N8920A-02

# Modification Recommended Service Note

## N8920A Autoranging System DC Power Supply

Serial Numbers: DE22350000 to DE23089999

Figure 1: Stuck Keypad

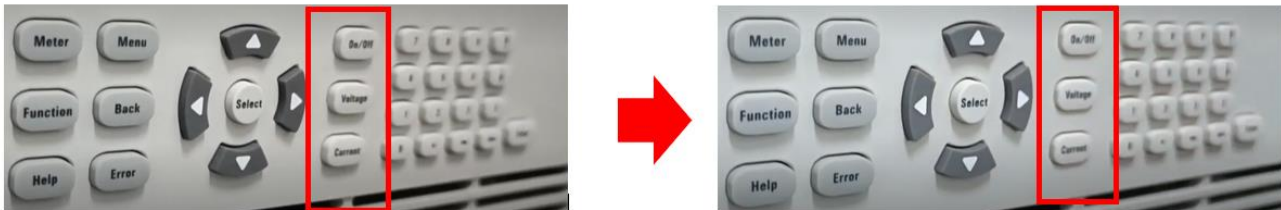
Unit in the above serial number range may intermittently encounter keypad stuck when pressing the keys at front panel. Figure 1 shows an example of a stuck keypad, which could occur with any of the keys.

Kindly contact Keysight Technologies Customer Contact Center at [www.keysight.com/find/contactus](http://www.keysight.com/find/contactus) for sending the affected unit back.
